WINSOME FILING NO. 3
EL PASO COUNTY, COLORADO
CONSTRUCTION DOCUMENTS
HORIZONTAL CONTROL

WINSOME FILING NO. 3
EL PASO COUNTY, COLORADO
CONSTRUCTION DOCUMENTS
CULVERT 1-PLAN & PROFILE

Culvert CDs_v1 redlines.pdf Markup Summary

WINSOME FILING NO. 3
 EL PASO COUNTY, COLORADO
 CONSTRUCTION DOCUMENTS
 CULVERT DETAILS

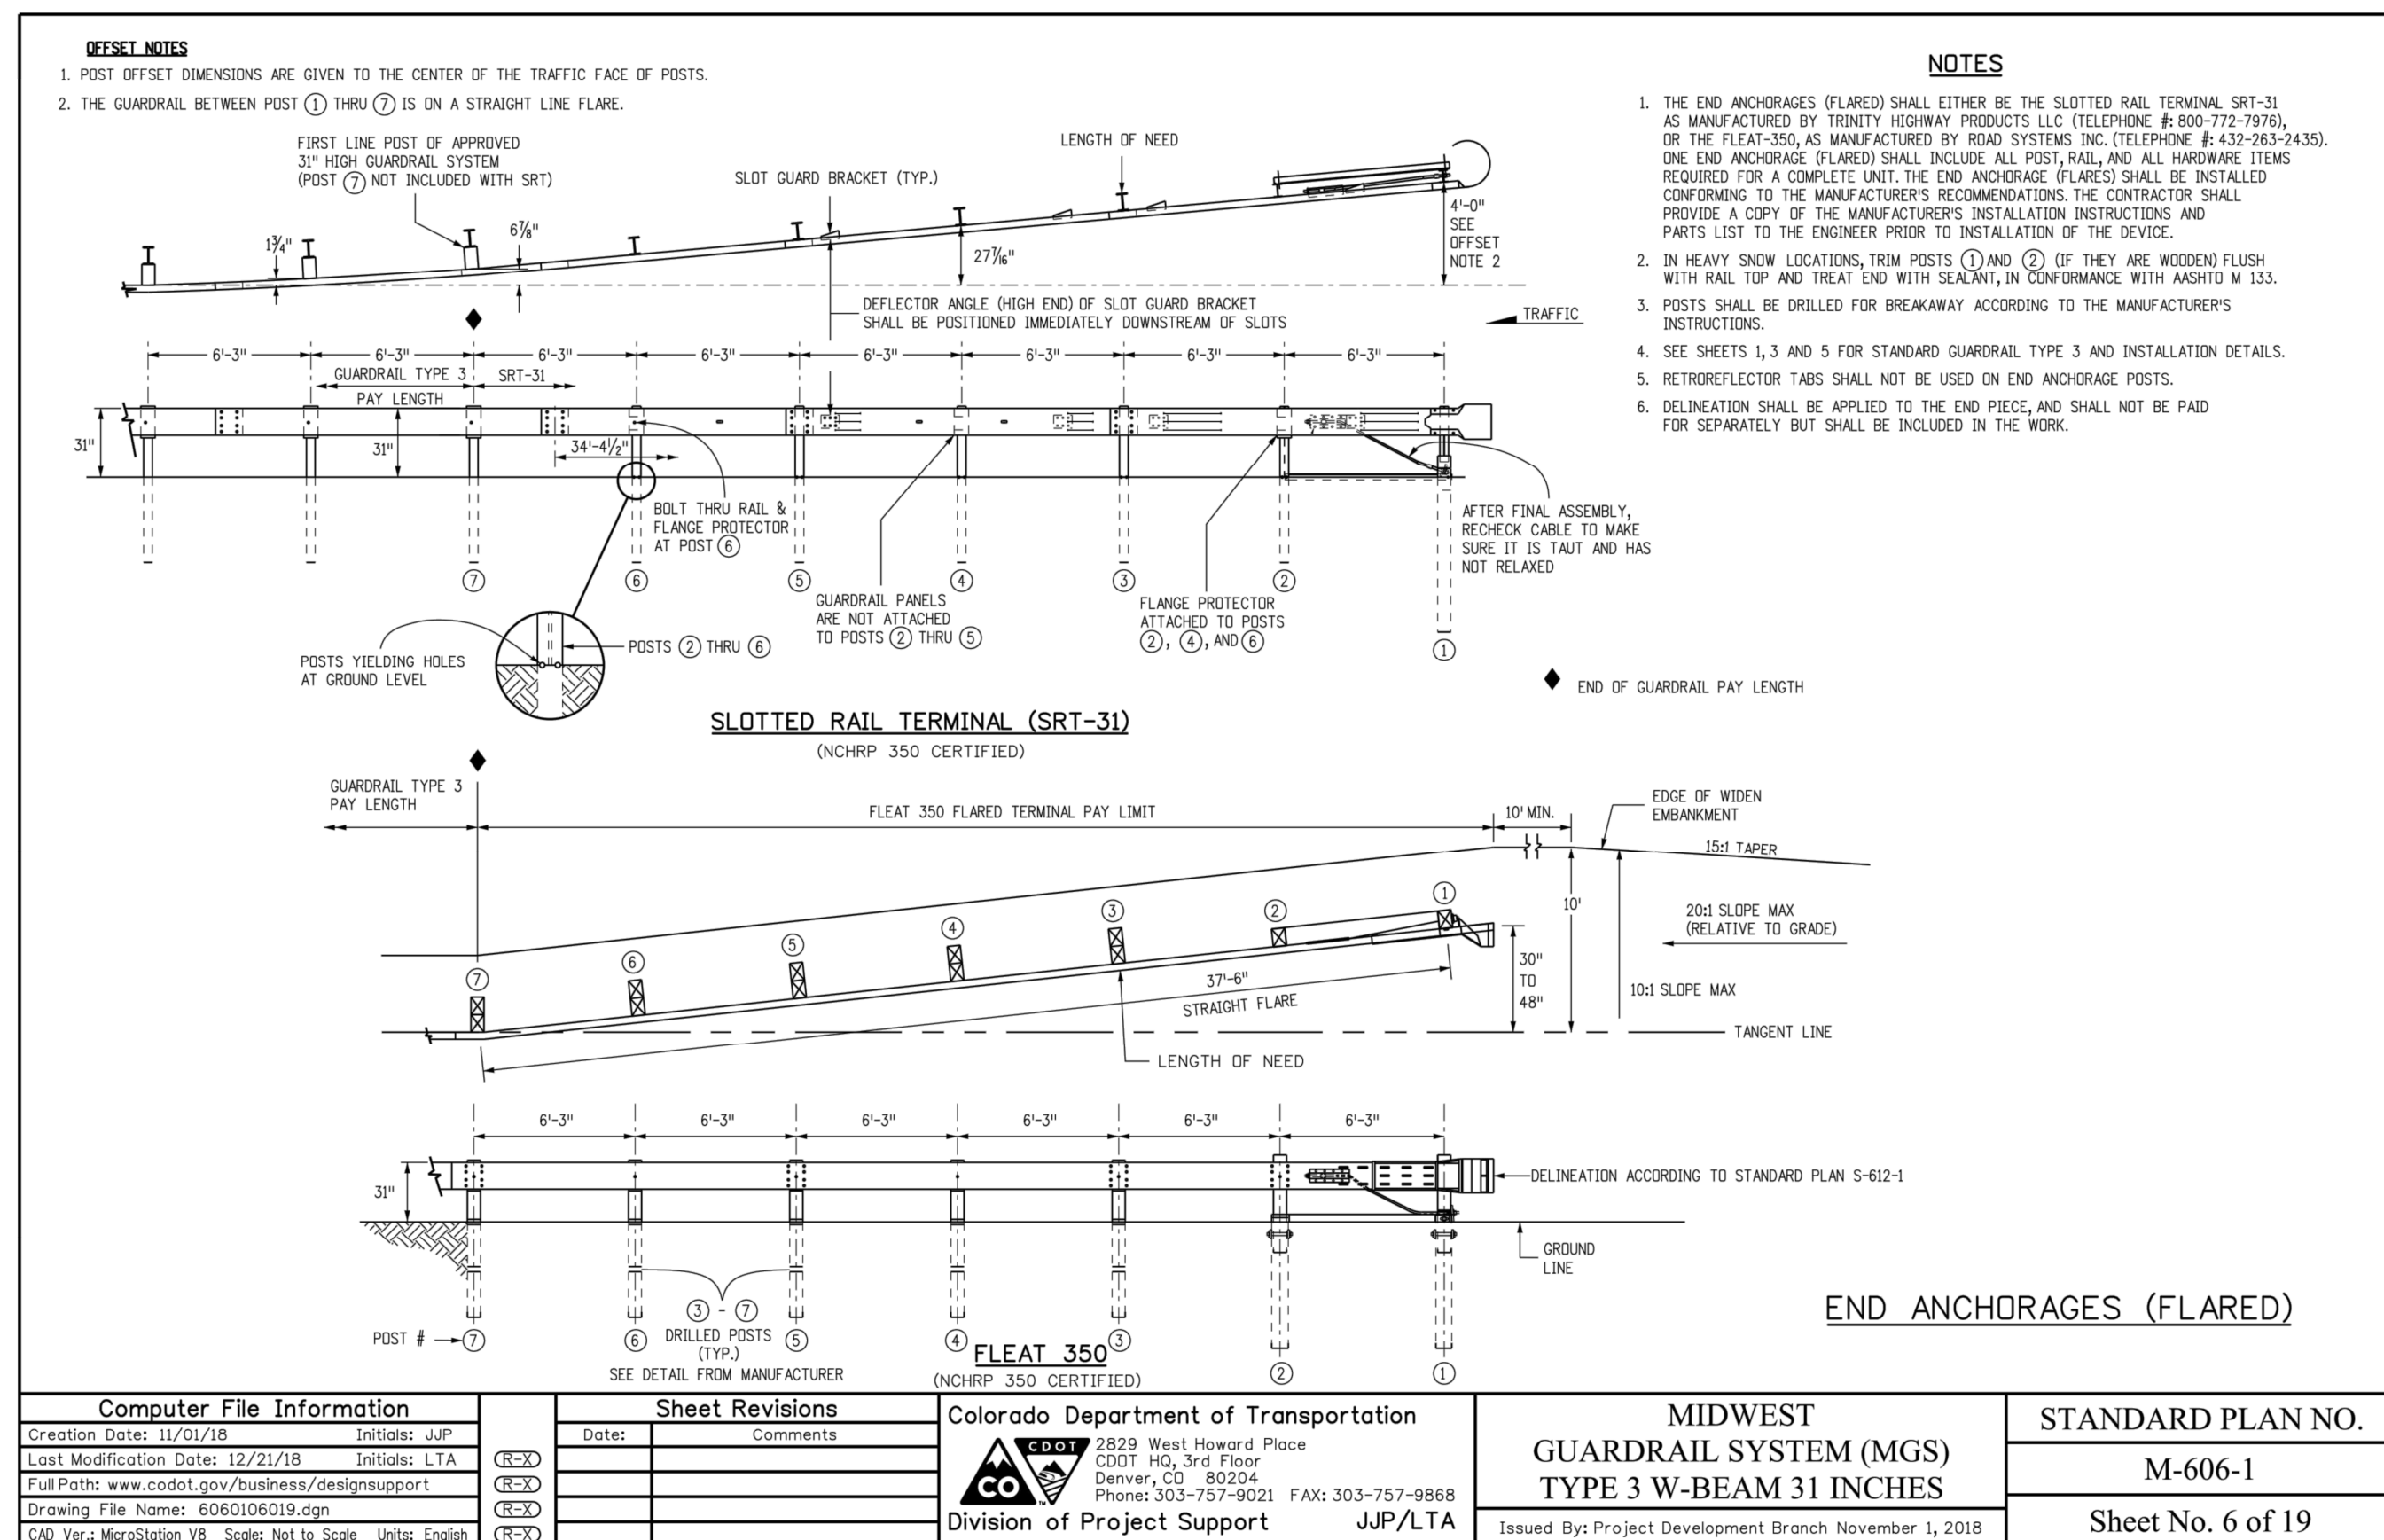
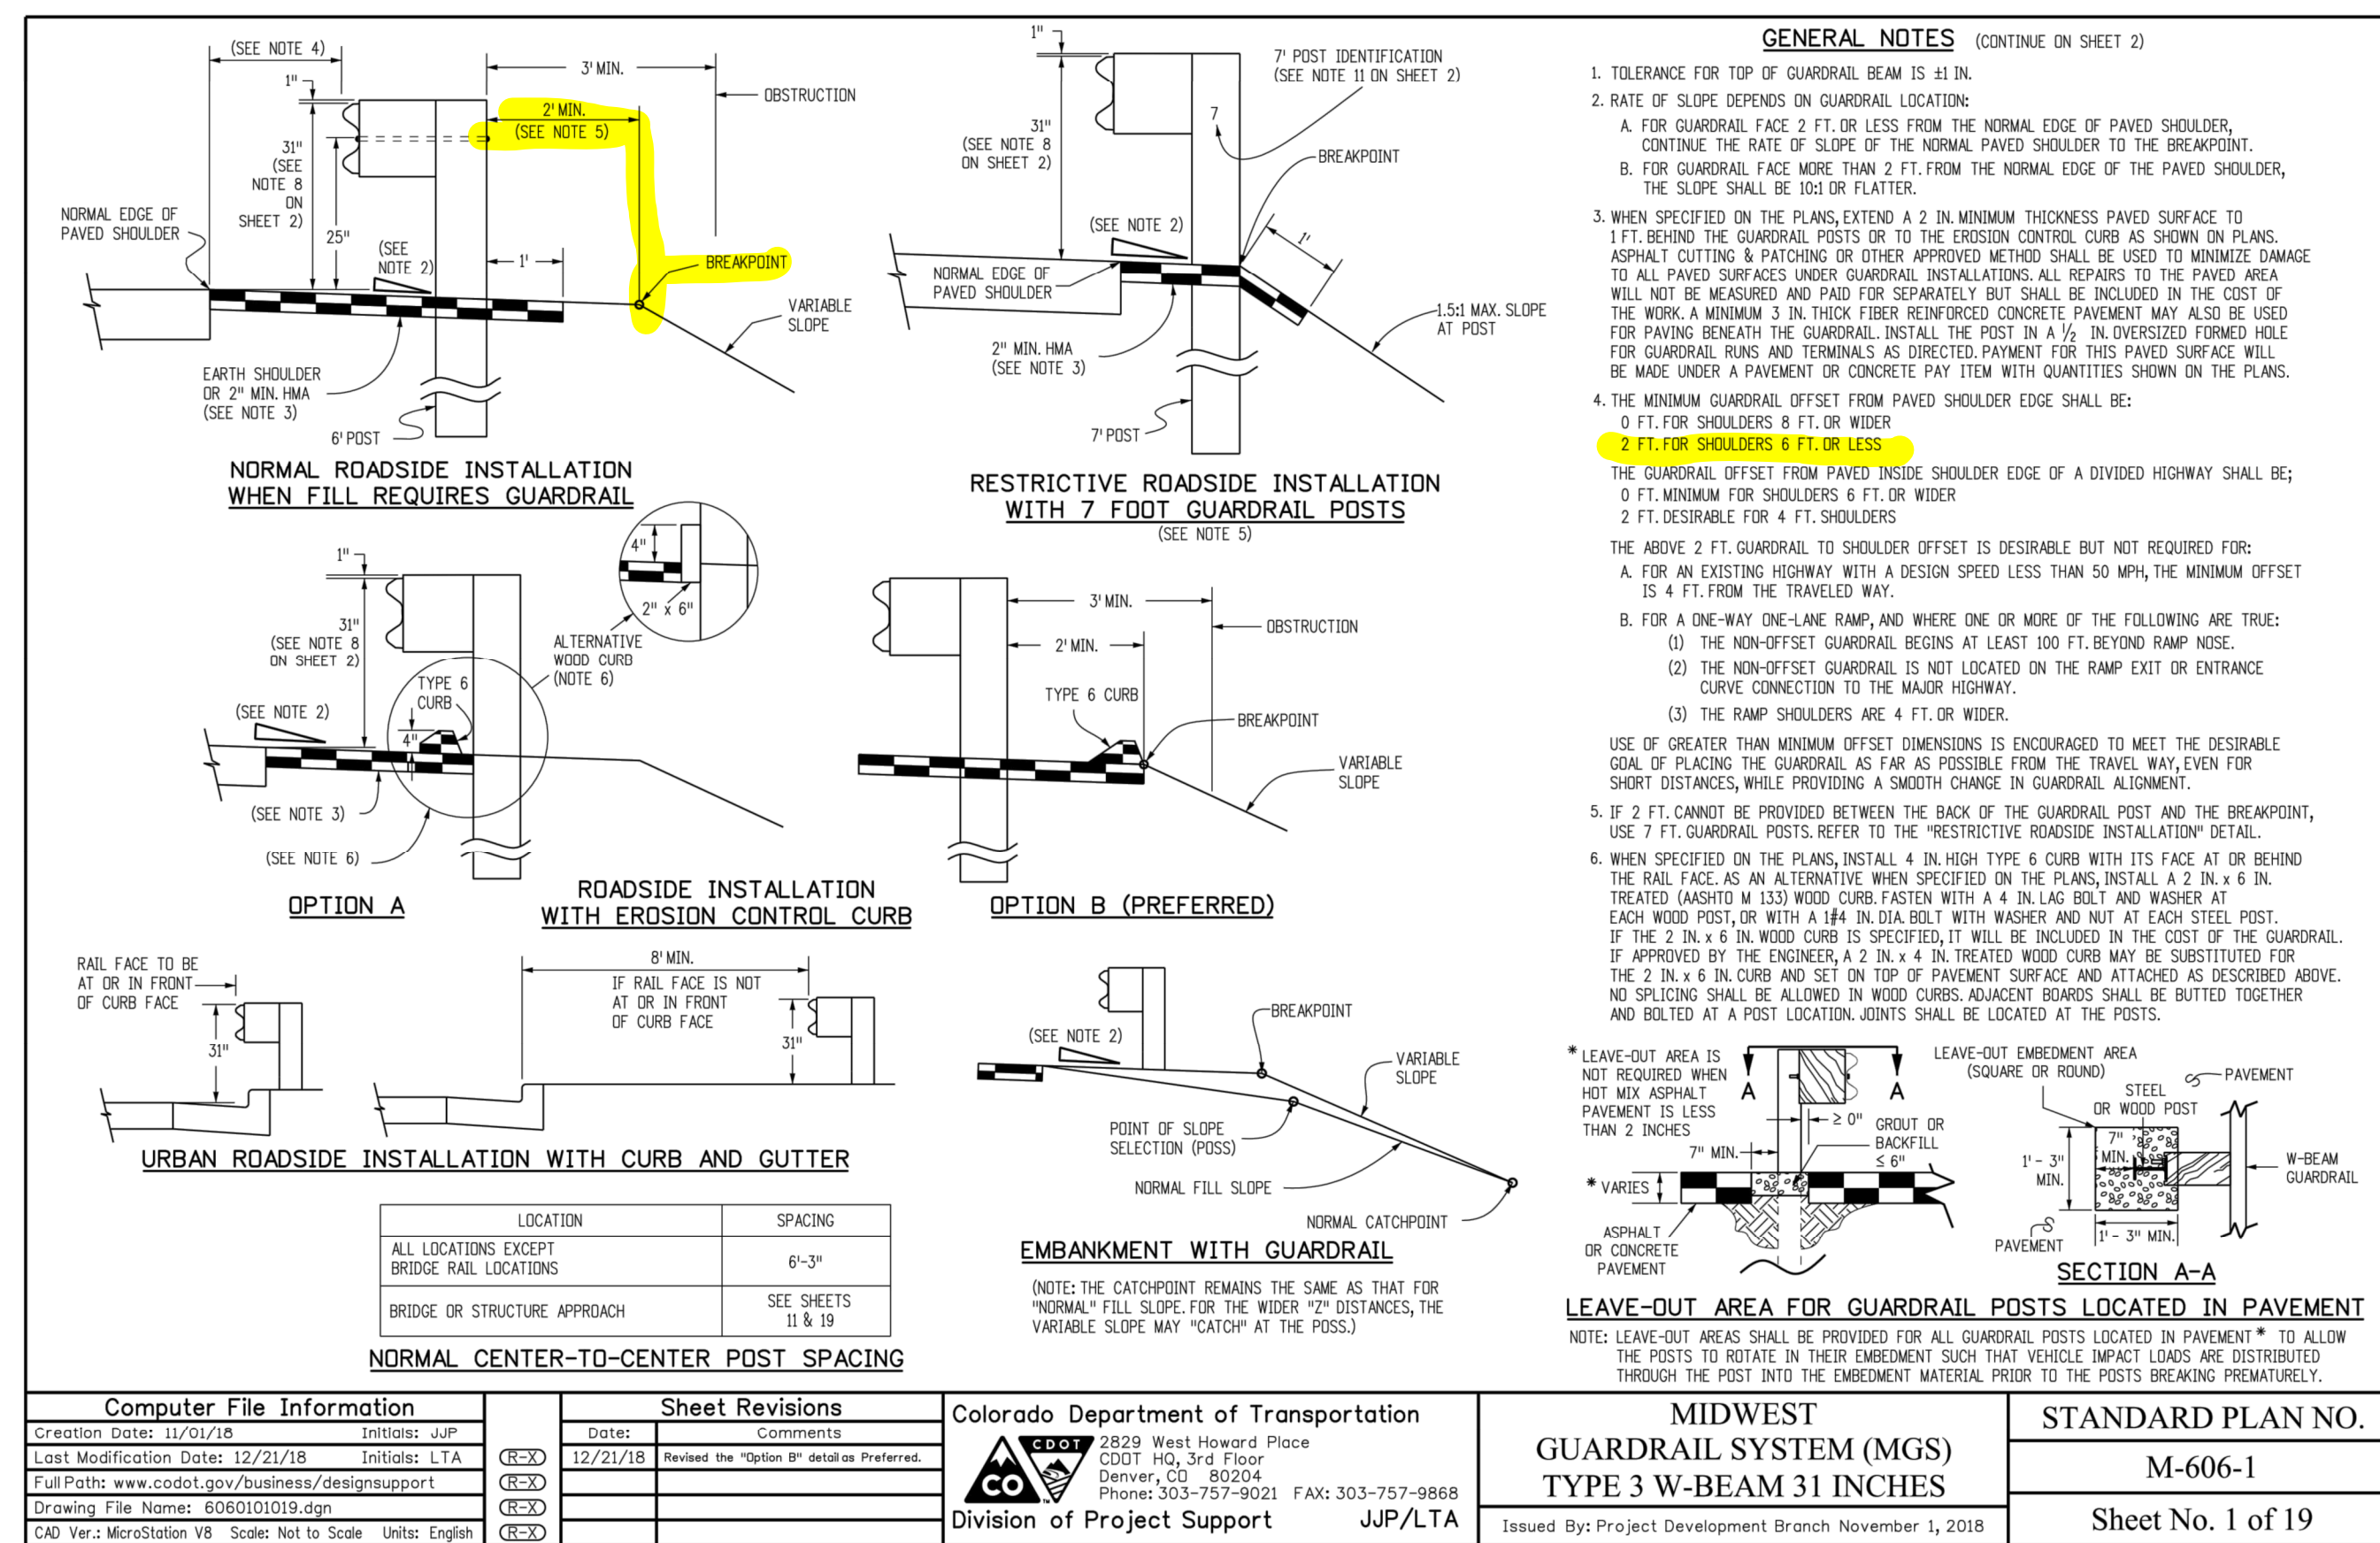
Add all the applicable CDOT Detail M-606-1 sheets

ADDED MORE APPLICABLE GUARDRAIL DETAILS.
